# CONTRACT 5009 WATER TREATMENT PLANT GENIUS BUS REPLACEMENT PROJECT

## ADDENDUM NO. 2

Issued: 8/30/23

**SITE PLAN**  
 SCALE: 1"=30'

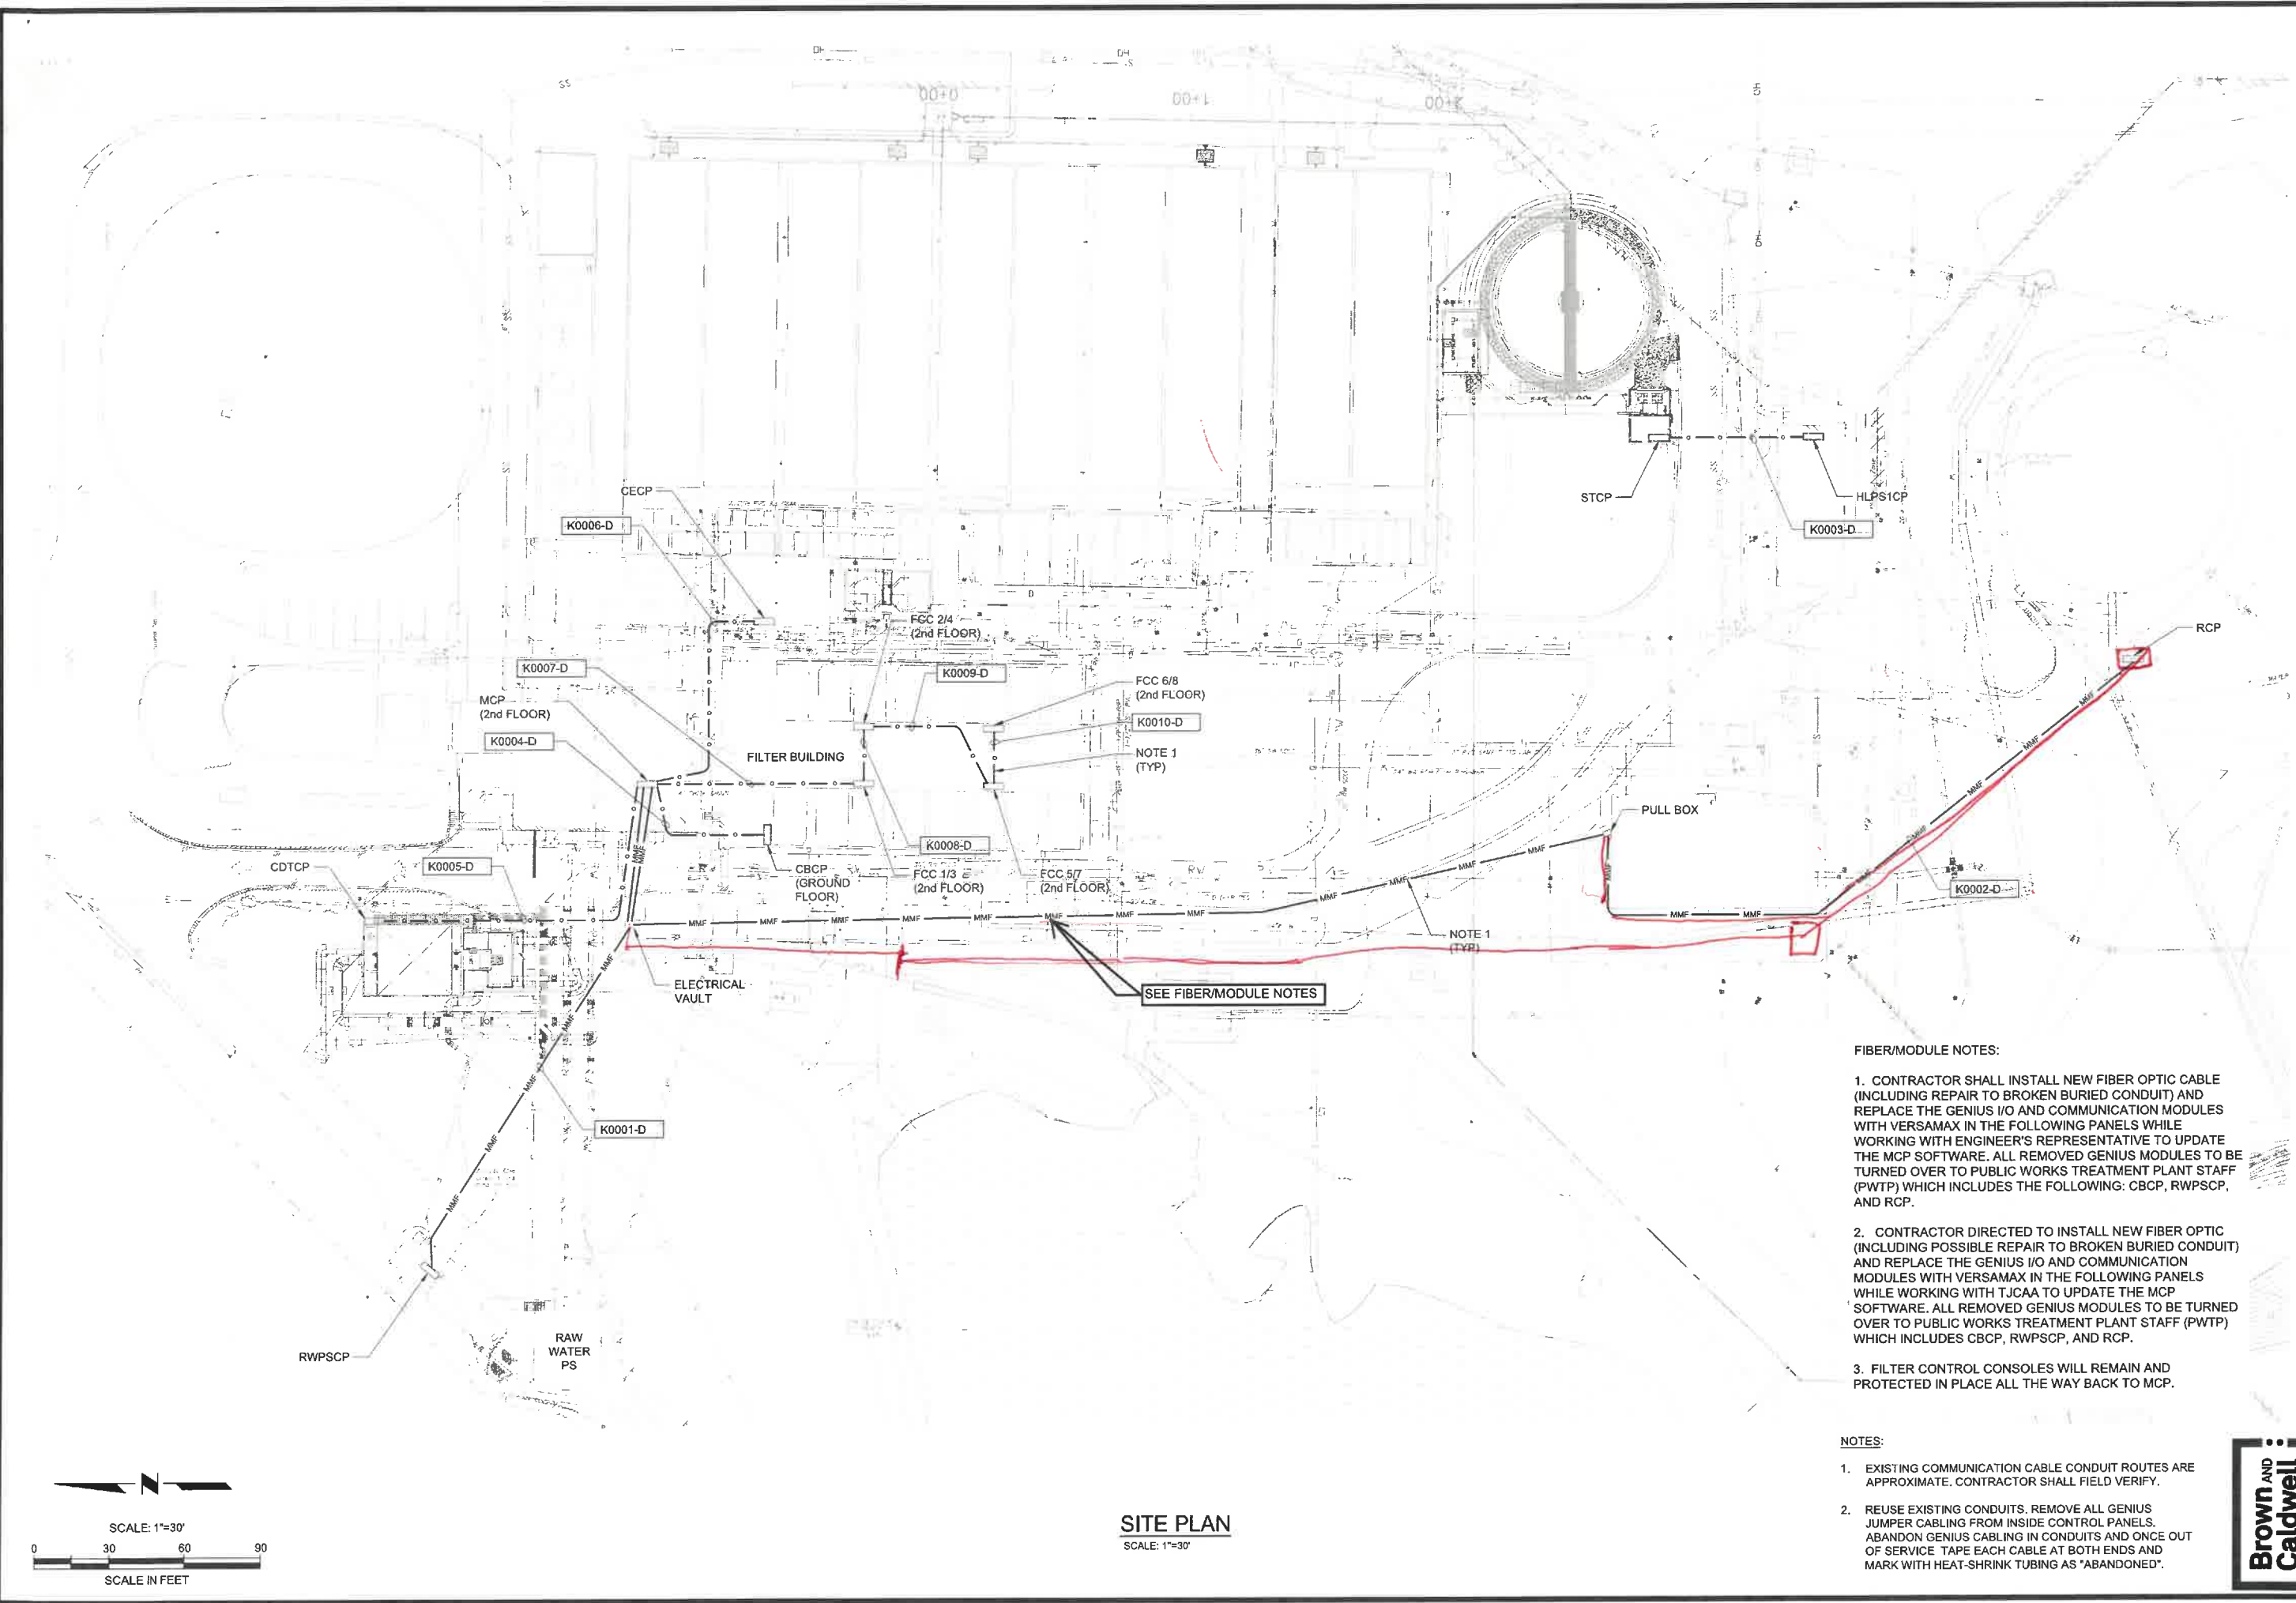
- b. What size and quantity of conduits are required for the underground build?
    - i. *Response: 2-2 inch conduits for the Fiber runs and 1-2 inch conduit for the ethernet cable runs.*

- i. *Response: Contractor shall assume 2 – 3'x4' precast communications vault. Approximate Locations shown on the attached documents*
  - e. Does the scope of work include repairing existing damaged conduit?

- i. *Response: Contractor shall assume 50% of existing conduit is damaged. However, in lieu of repairing the contractor can choose to install new for constructability at no additional cost to the project.*
